PLANNING AND DEVELOPMENT SERVICES STAFF REPORT

For Planning Commission Meeting of October 18, 2011

**SUBJECT: University of Michigan Credit Union Landscape Modification Request
(340 East Huron Street)
File No. SP11-027**

SHEET #: C-001

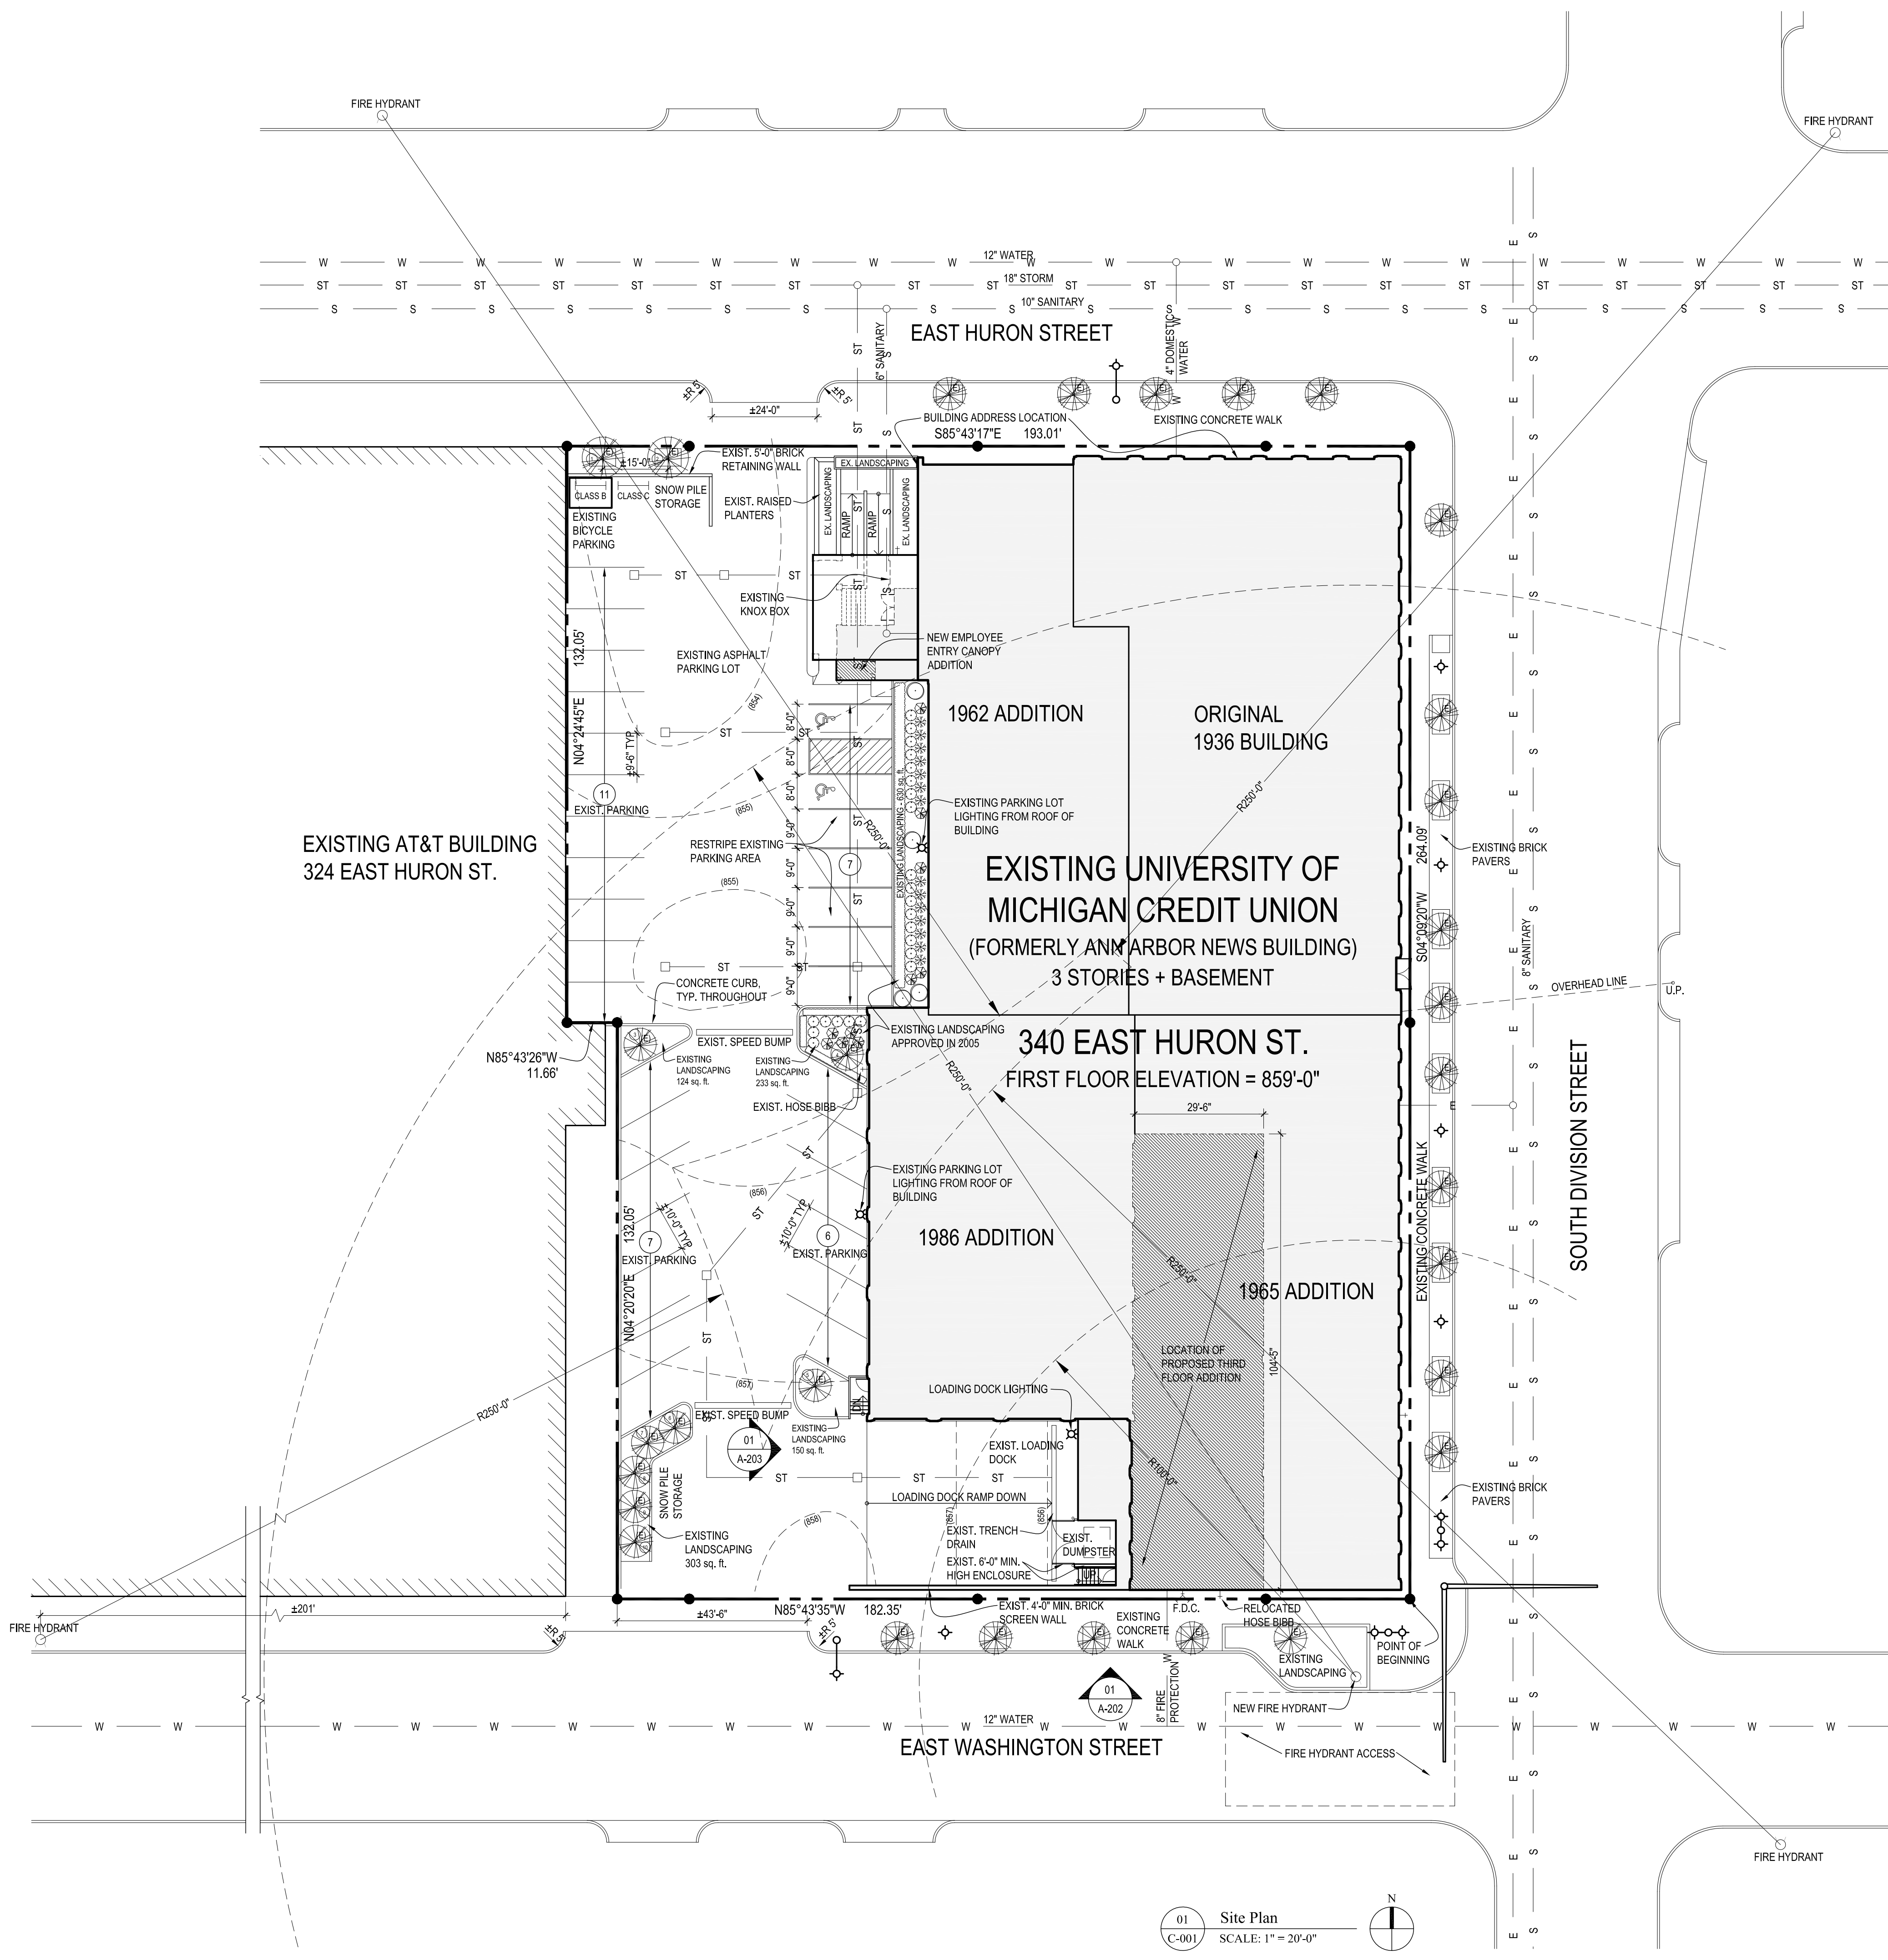
The most recent site plan on file was approved on October 7, 1994, for the Ann Arbor News building. The site currently matches the approved site plan. The non-conforming landscaping in the existing parking lot includes:

- 630 square feet of landscaping along the western building does not extend into the vehicular use area and cannot be counted toward interior landscaping requirements.
- The 124 and 150 square foot landscape islands do not meet the minimum 165 square feet for interior landscape islands.
- The southern 303 square foot landscape island is right-of-way buffer screening and cannot be counted toward interior landscaping requirements.

- The right-of-way buffer screening along Huron Street is less than the required 10 feet in width.
- The required right-of-way buffer screening along East Washington Street cannot be provided without removing the loading dock.

While the intent of the landscape code is to screen the vehicles from the right of way and to break up the expanse of pavement, existing interior and right-of-way screening landscaping exists and met the landscaping code when the previous site plan was approved.

Staff recommends that this petition be **approved** because the modifications are consistent with the intent of the ordinance and are associated with a previously approved site plan.
